**SECTION 00 90 01
BIDDING AND CONTRACT REQUIREMENTS
ADDENDUM NUMBER 1**

Issued: April 28, 2026

**Fire Tower Replacement
Issued for Bid**

Architect's Project Number: 25-028

2 EAST ELEVATION
 1/4" = 1'-0"

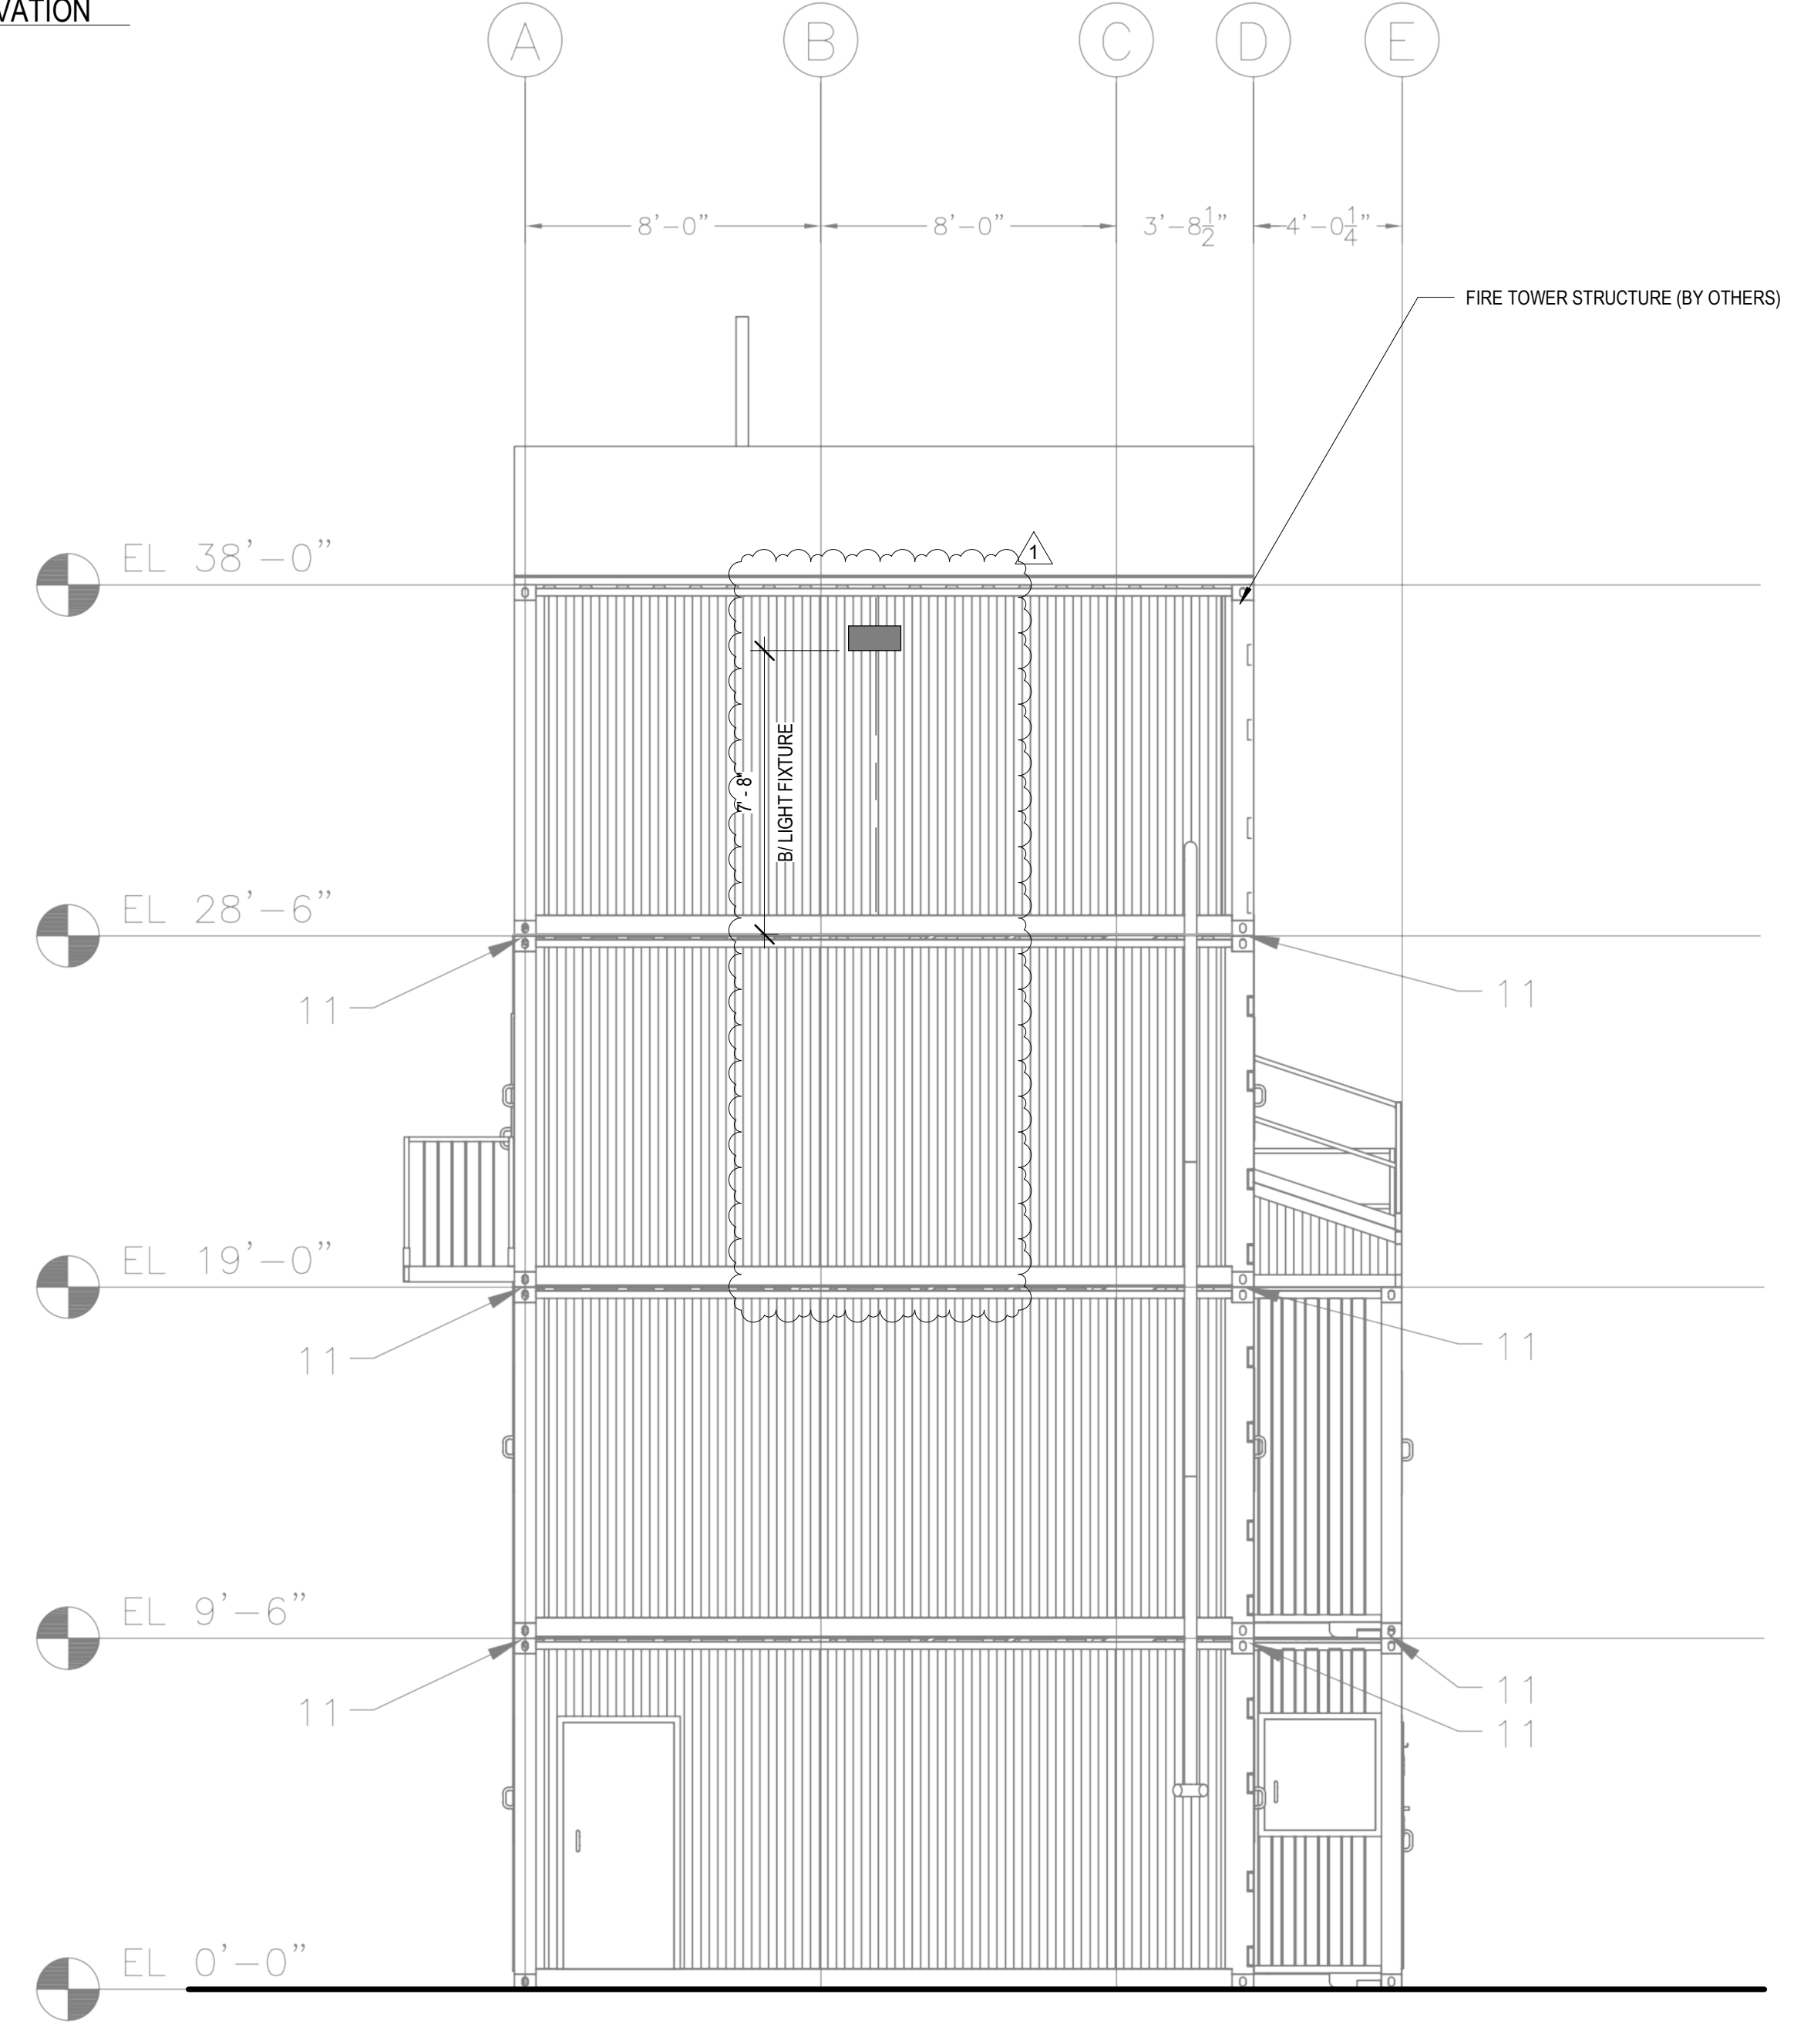
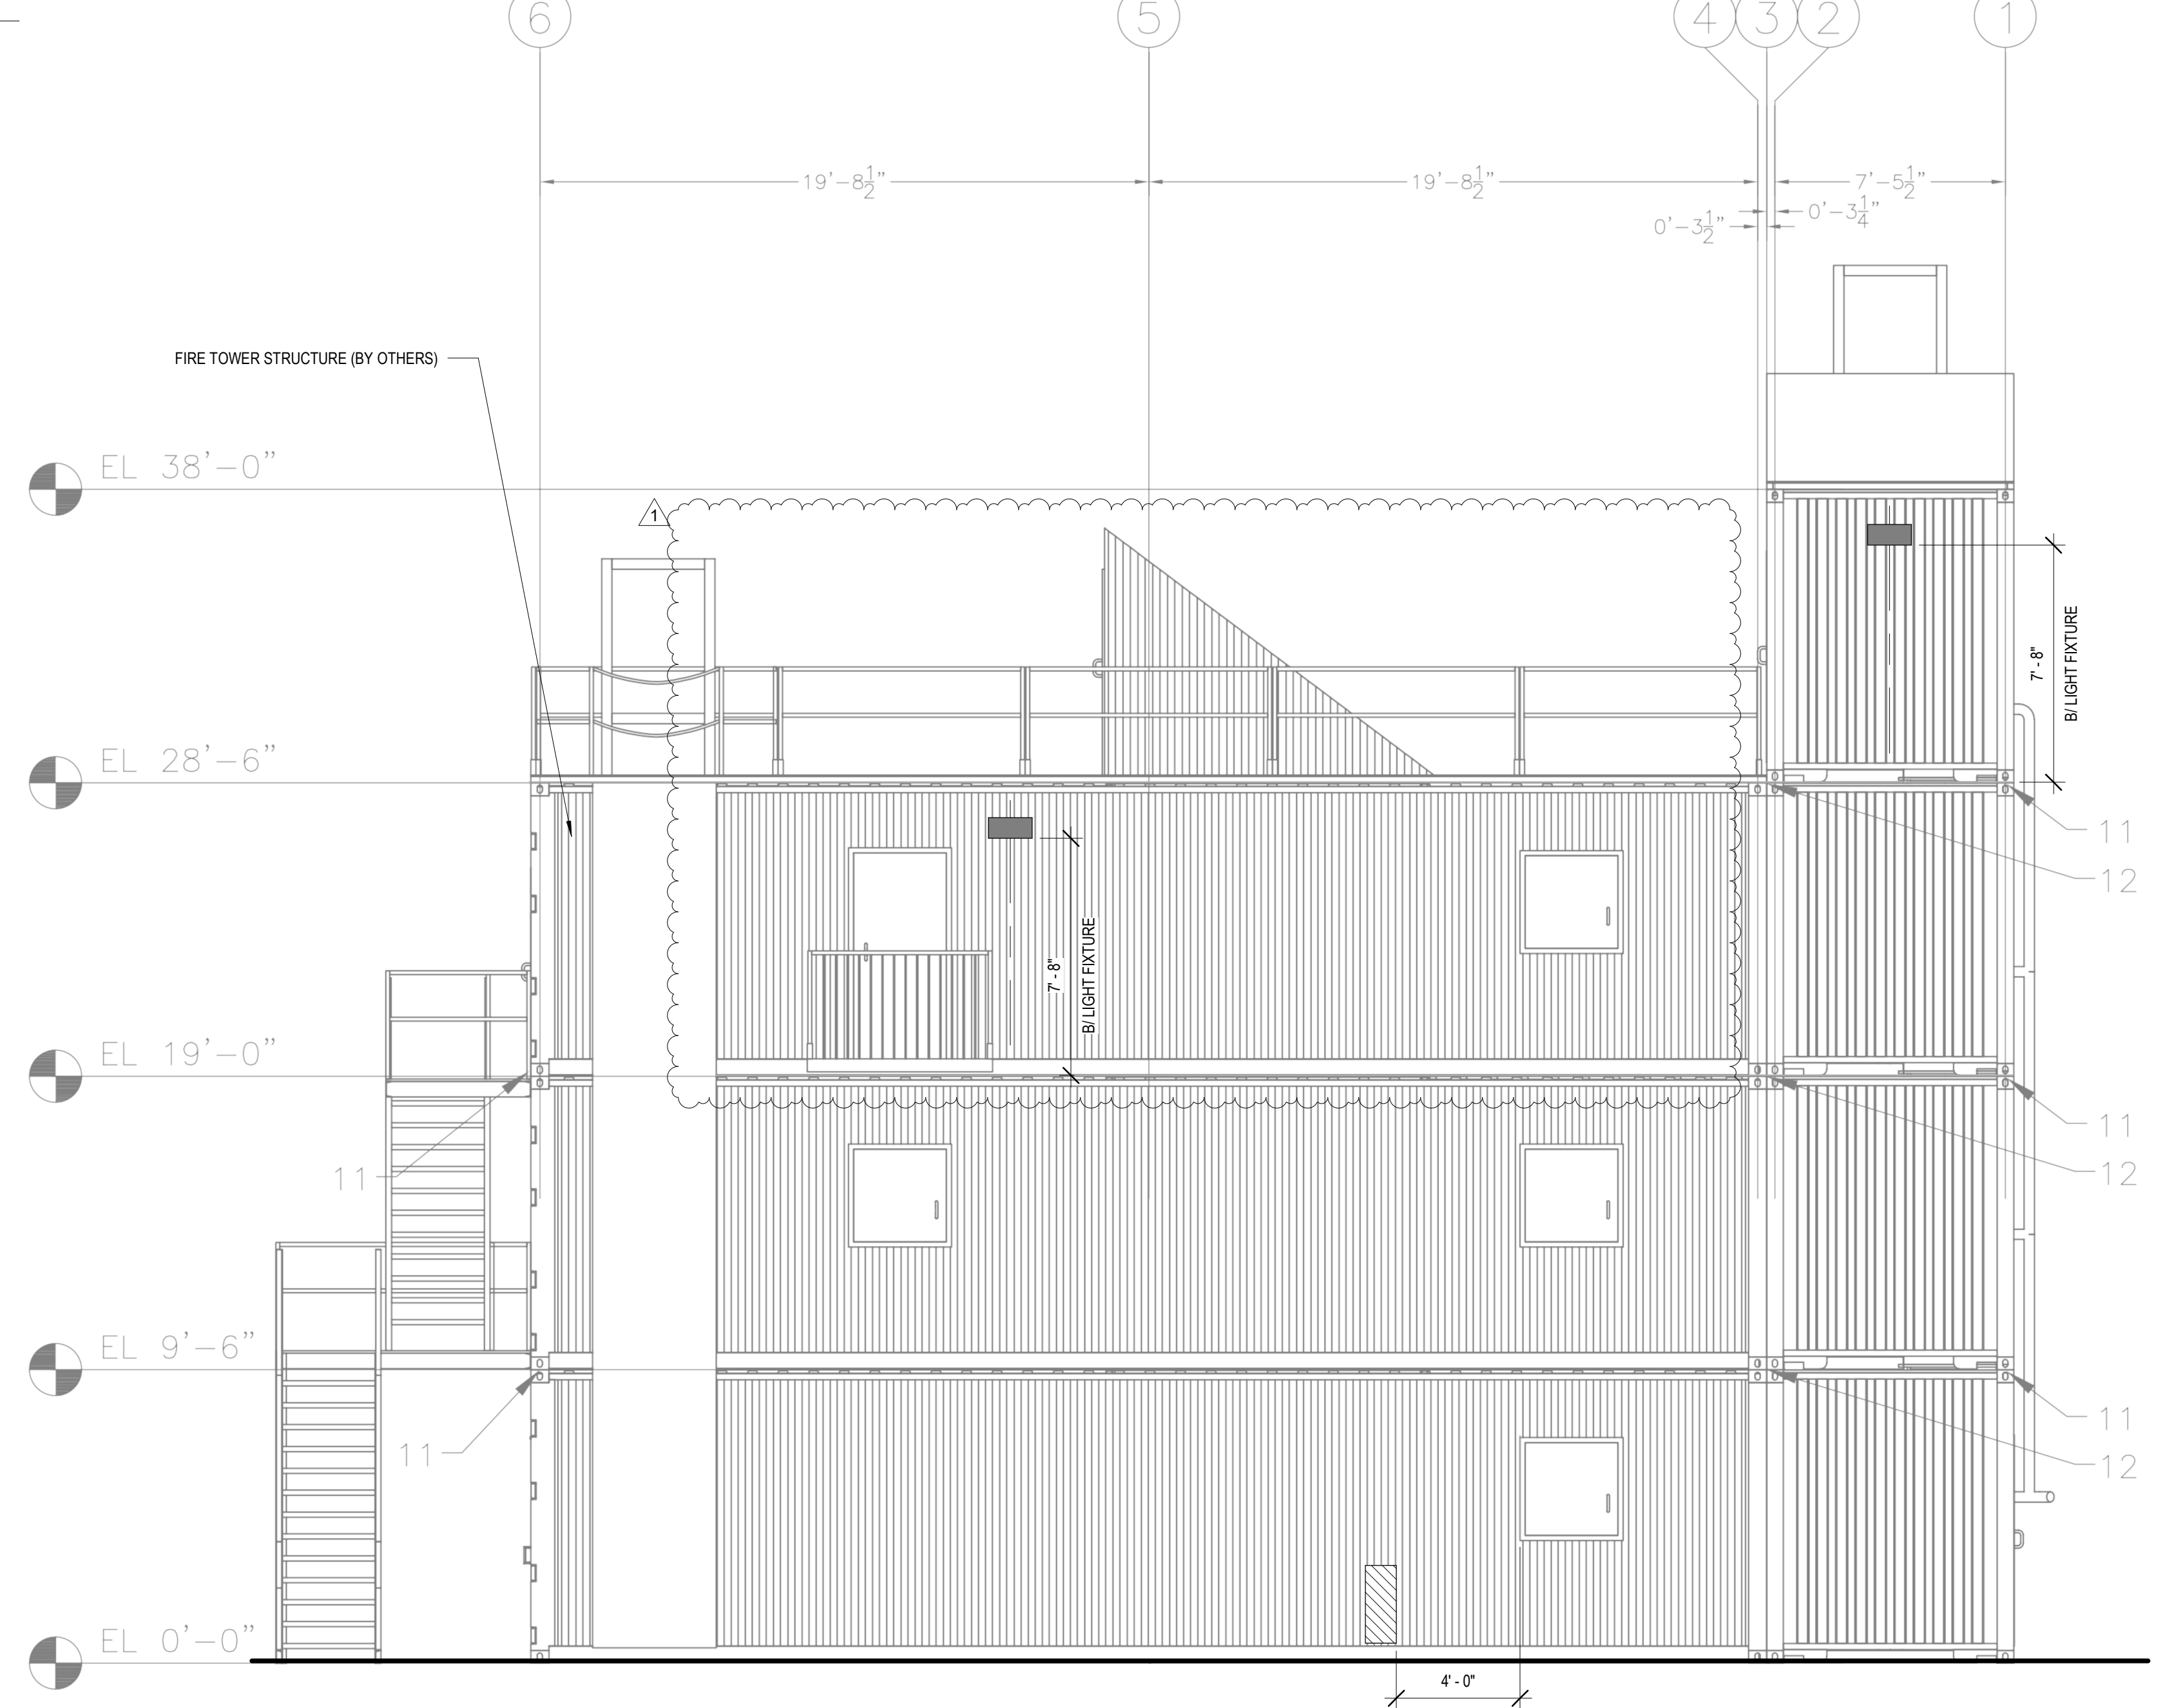
2. A4.00
 - A. **REVISE** exterior lighting locations on all elevations. See Electrical drawings.

SHEET NUMBER:
E1.00

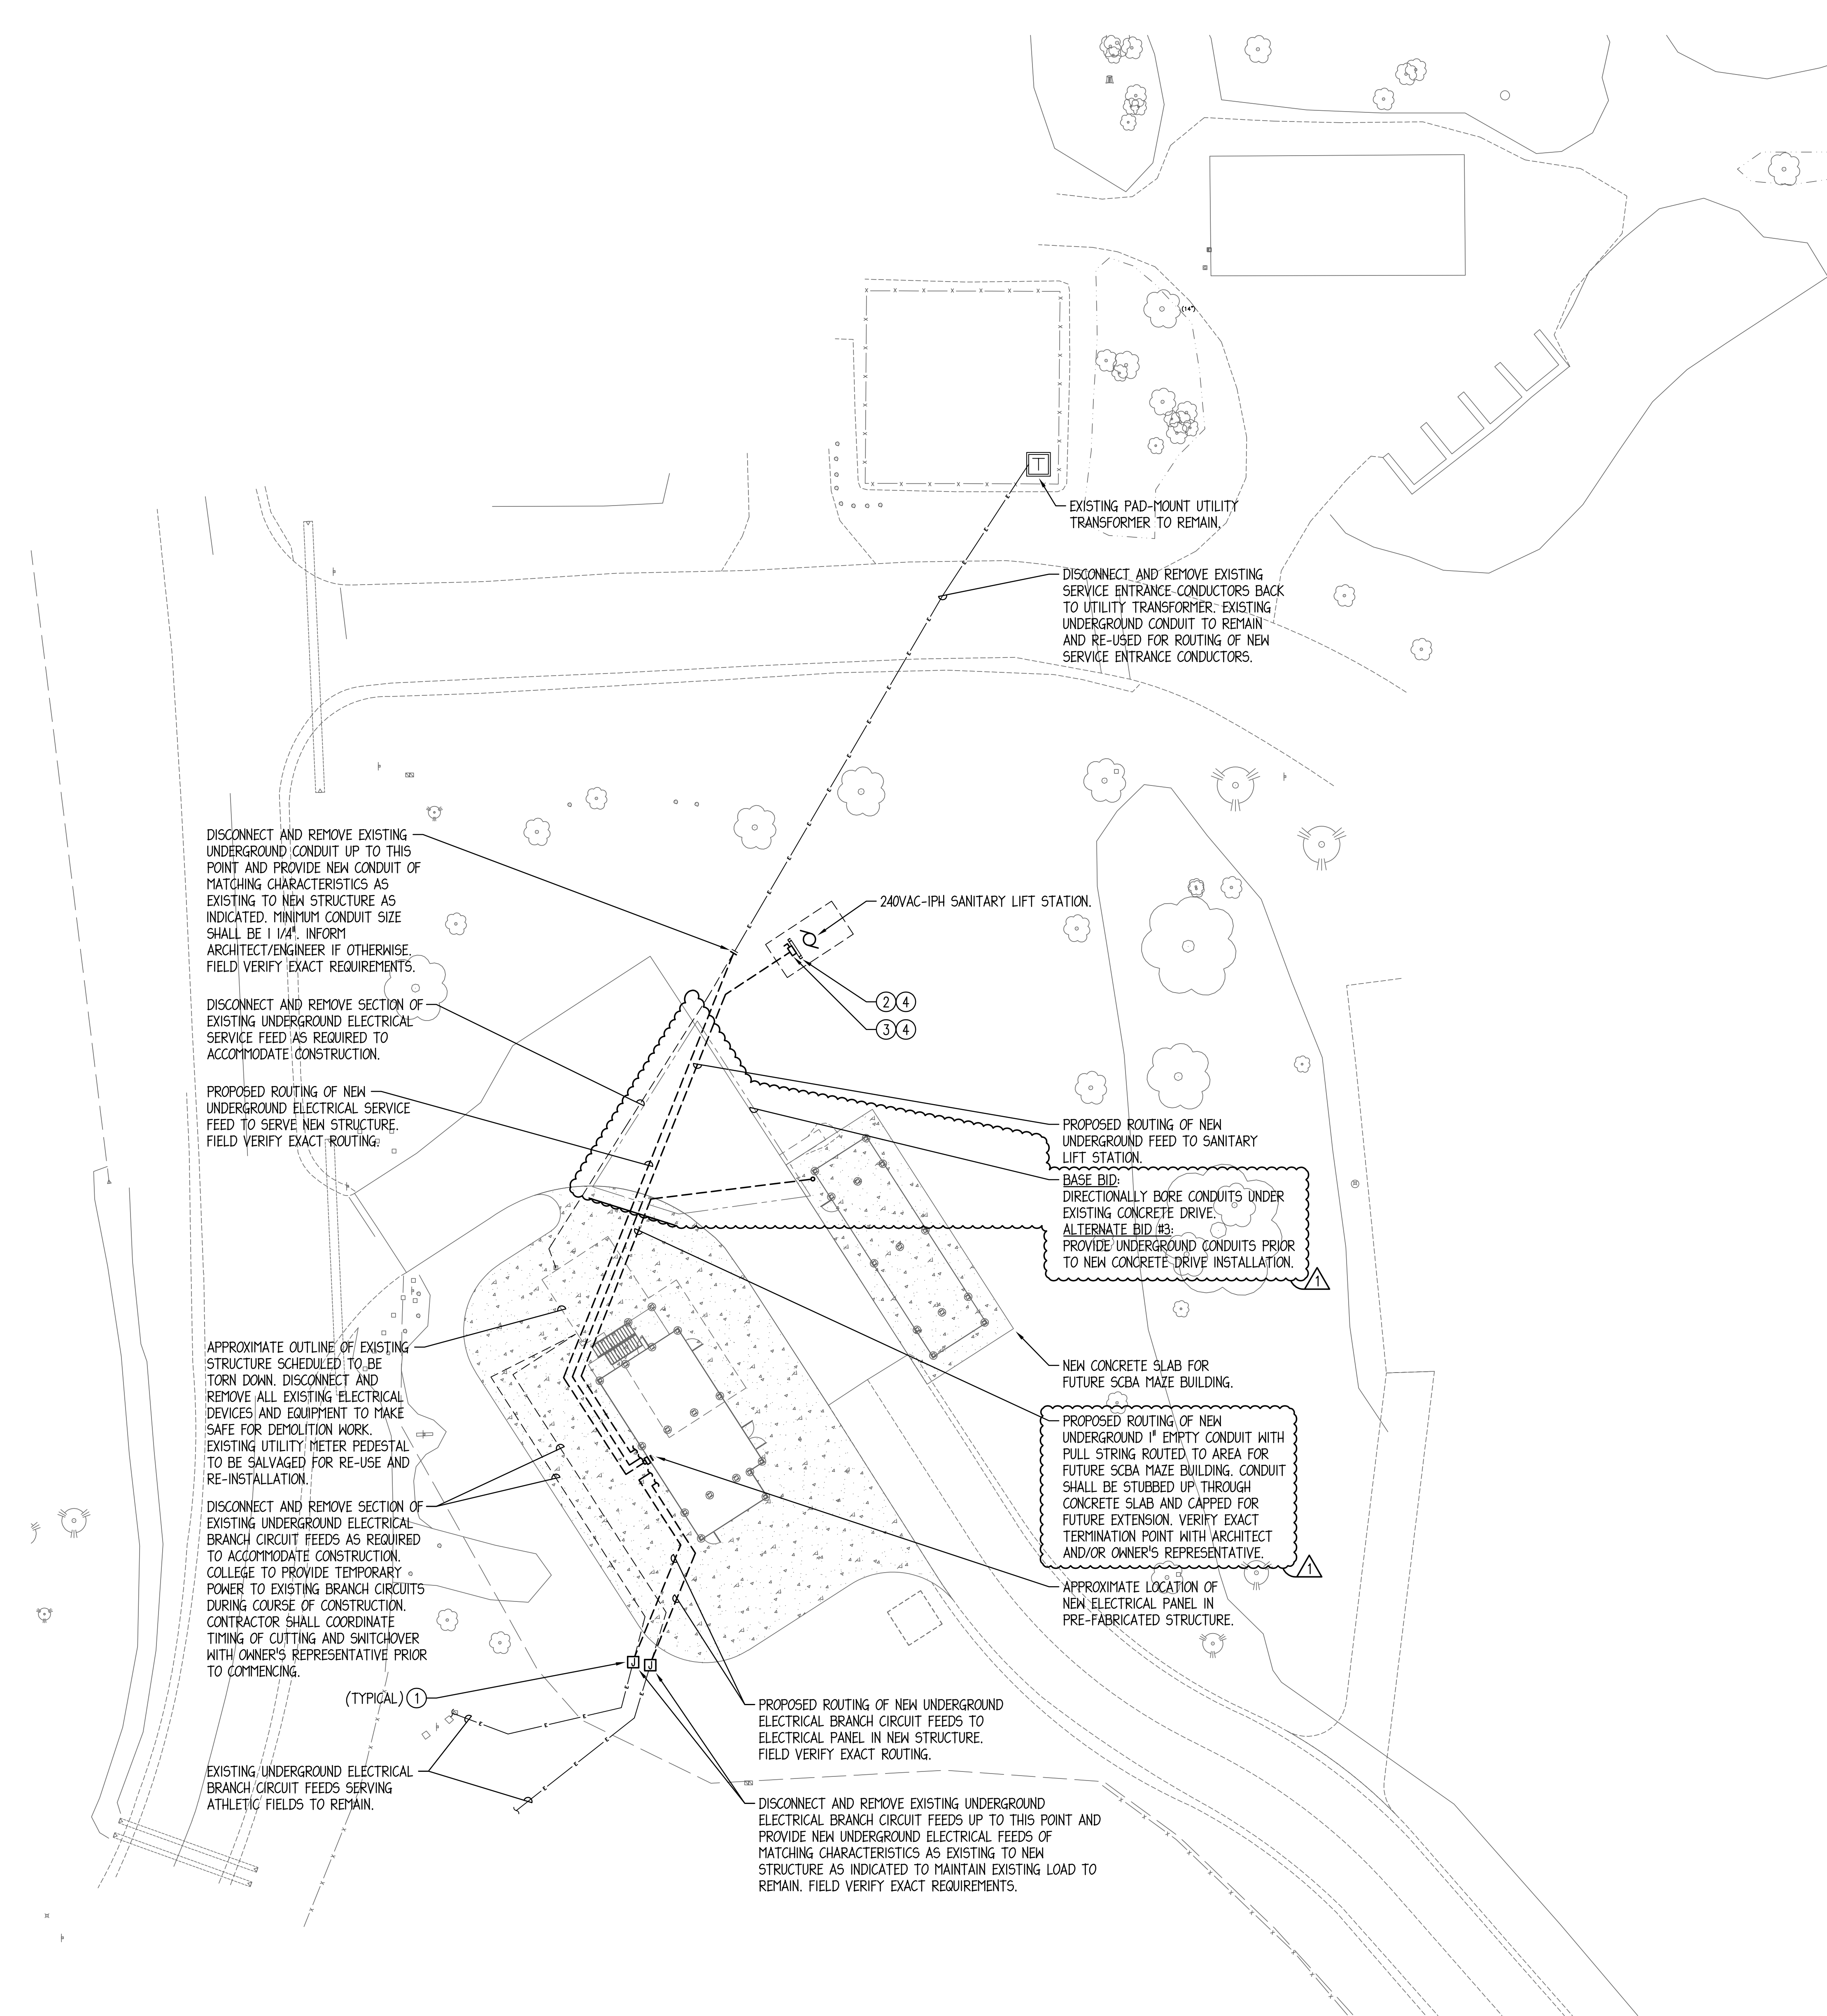
1. E1.00
 - A. **ADD** note for installation of conduits below concrete drive.
 - B. **REVISE** note for conduit stub out to future SCBA maze building.
2. E1.10
 - A. **ADD** general note #6 to drawing.
 - B. **ADD** luminaire shown on 'FIRST FLOOR ELECTRICAL PLAN'.
 - C. **ADD** luminaire shown on 'SECOND FLOOR ELECTRICAL PLAN'.
3. E1.20
 - A. **ADD** general note #6 to drawing.
 - B. **REVISE** luminaires shown on 'THIRD FLOOR ELECTRICAL PLAN'.
 - C. **REVISE** luminaires shown on 'FOURTH FLOOR ELECTRICAL PLAN'.
4. E2.00
 - A. **REVISE** 'LUMINAIRE SCHEDULE' as shown.
 - B. **REVISE** 'LIGHTING CONTROL RELAY PANEL SCHEMATIC DIAGRAM'.
